# Faculty and Family Student Housing, Open Space Plan, and LRDP Amendment EIR Addendum

# 1.2 SUMMARY OF NEW INFORMATION AND REVISIONS TO PROPOSED PROJECT

REVISED NORTH PARCEL FACULTY HOUSING PLAN FIGURE 2.2

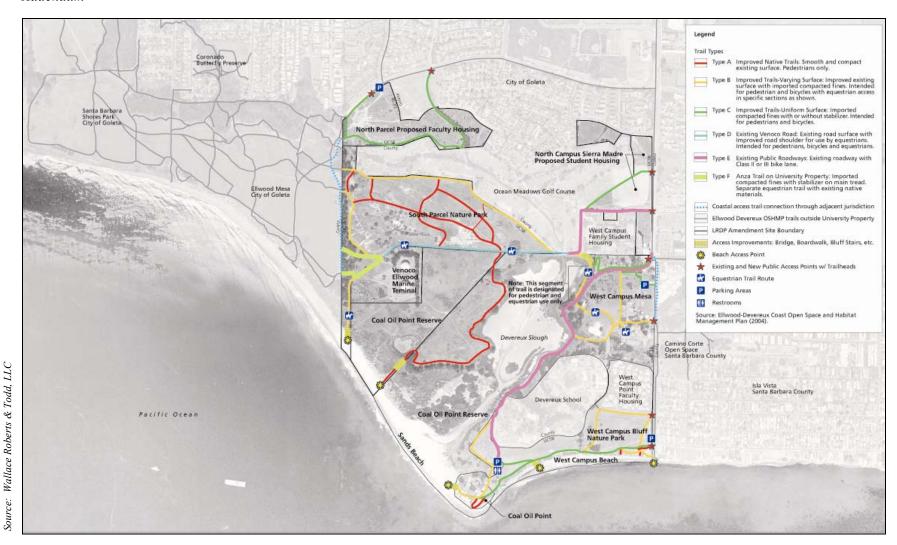
Since the adoption of the 2004 FEIR the proposed North Parcel faculty housing project site plan has been revised to preserve all Coastal Act wetlands (0.92 acres total – a 0.6-acre decrease from that analyzed in the 2004 FEIR), while meeting the University's objective of providing much needed affordable housing to its faculty. As revised, the North Parcel site plan eliminates 47 structures (from 120 to 73), and includes 21 fewer faculty housing units (215 total). The revised plan also reduces construction-related grading and site disturbance by up to 7.8 acres (15.2 acres total as compared to the originally proposed 23 acres). Three fewer single-family detached homes (9 total) are proposed, and the number of two-story buildings has been decreased from 78 to 15, consisting of 8 courtyard duplexes (17 units), 3 studio-above-garage units, and 4 townhomes (19 units). Four single-story detached garages are associated with the 4 two-story townhomes (reduced from 22). Twenty-five three-story townhomes (87 units) and 20 mixed two/three level fourplex structures (80 units) are also proposed.

The maximum building height analyzed in the 2004 FEIR would not change (35 feet). Approximately 0.92 acres of coastal wetlands/vernal pools would be avoided and protected by buffers ranging from 25 to 100 feet. Buffer zones and wetlands would be restored pursuant to a Sensitive Habitat Restoration Plan (SHRP), including a 50-foot riparian buffer zone associated with Phelps Ditch. In addition, a description of the Devereux Creek culvert, including areas of disturbance and project elements has been added.

The North Campus Faculty Housing project will reduce the number of housing units from 236 to 215 on the North Parcel of the North Campus, north of the Ocean Meadows Golf Course (refer to Figure 2.2). The site is designed with buffers ranging from 25 to 100 feet around identified Coastal Act Wetlands. The project will provide a range of housing types and sizes in a total of 73 buildings (reduced from 120) including: 80 units in 20 mixed two/three-story four-plex townhomes; 87 units in 25 three-story townhomes; 19 two-story units in 4 townhomes with 4 associated single-story detached garages; 17 units in 8 courtyard duplexes;; 3 two-story studio units, and; 9 detached single-family homes.

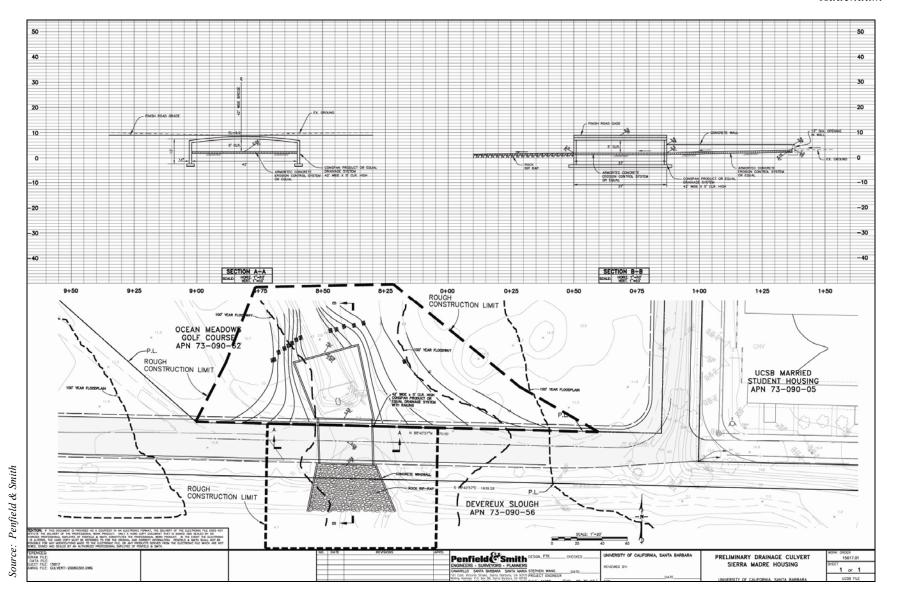
The 2004 LRDP Amendment proposed to remove the existing 36-inch diameter concrete culvert passing through a concrete summer crossing and directly upstream an existing concrete sediment trap with a 12-inch diameter opening located at the Venoco Road/Devereux Creek crossing adjacent to the southern perimeter of the Ocean Meadows Golf Course. UCSB proposes to replace the weir with a pre-fabricated 42-foot span bridge/arched-culvert structure, 37-foot wide by 5-foot high (refer to Figure 2.4). The proposed replacement would lower the water surface elevation at the culvert by 1.07 feet during a 100-year flood event. Additional concepts associated with the culvert would include:
